Application #: Zoning By-law Amendment ZBA21/008/K/BB
Official Plan Amendment OPA21/005/K/BB
Address: 890-900 King Street W.
Owner: Cantiro
Ward: Ward 9

The application is requesting relief from setbacks, parking and density requirements to permit a 25-storey building, including an internal parking structure, rooftop amenity terrace and a total of 231 residential dwelling units. To facilitate the redevelopment, the owner has requested to add a special policy area to the Official Plan to permit a floor space ratio of 10.1 (as shown on the attached Schedule A), and that a special regulation provision be added to the zoning by-law to allow for the increase density, reduced building setbacks and parking requirements.

Concept Plans and Elevations– SRM Architects

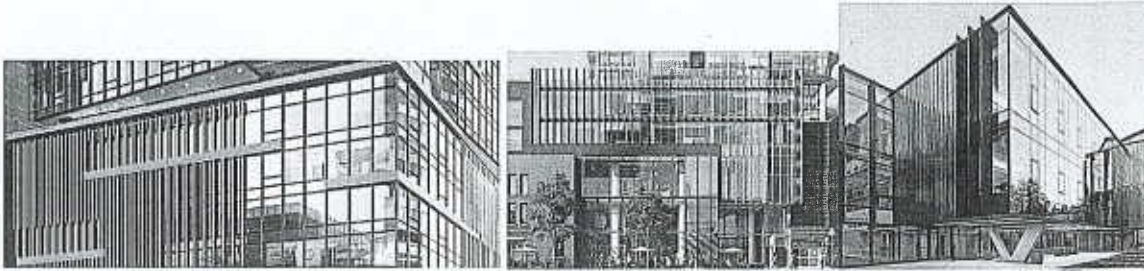
Given the location of the building, the proposed tower will be a city landmark and have a significant impact on the neighborhood. Due to the importance of the project, the management team has reviewed the proposal and recommended further improvement to exterior design to enhance its positive contribution to the local urban context.

Please review the following comments that I added to enhance the exterior design of the building:

- The proposed angled wall (chamfer) on the corner is not well integrated with the rest of the podium and has not been reflected in the tower design.
- There are three entry doors proposed along king street with similar detailing and material. The proposed corner treatment to be further enhanced to create visual interest at the street edge by using a different material or glazed system. Here are some design options:
- There is an option to have a square design on the corner, marked by the main feature of the building that projects out from the façade and links the street with the body of the building. You may use the resulting recessed entrance on the ground floor to accentuate the main entrance proposed on the corner. This, along with the wrapped or extended balconies above, will provide architecture features that enhance the corner treatment.

- For the podium design along King street, you may utilize different size window panels or perforated metal panels to provide further screening for the structured parking and a distinguished design.

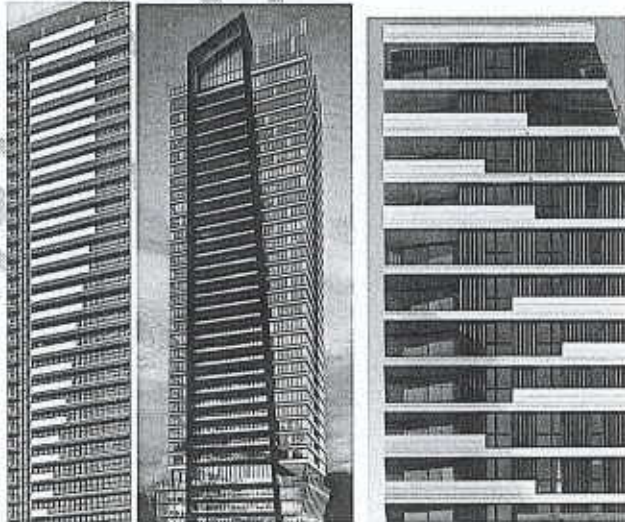
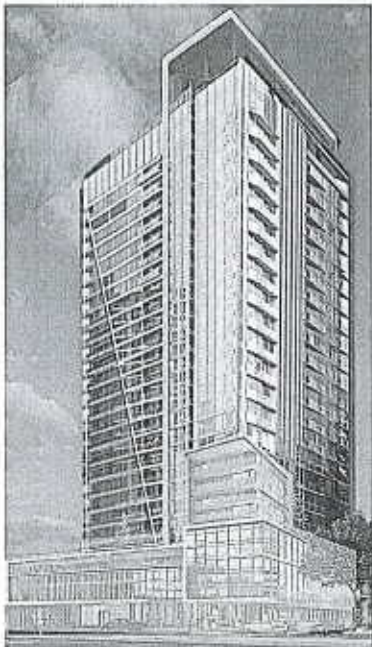
- Balconies may be staggered in a creative pattern to lighten the structure and provide private outdoor space for the units.
- The proposed tower may be expressed with alternating solid cladding around balconies and glass curtain walls around living areas.
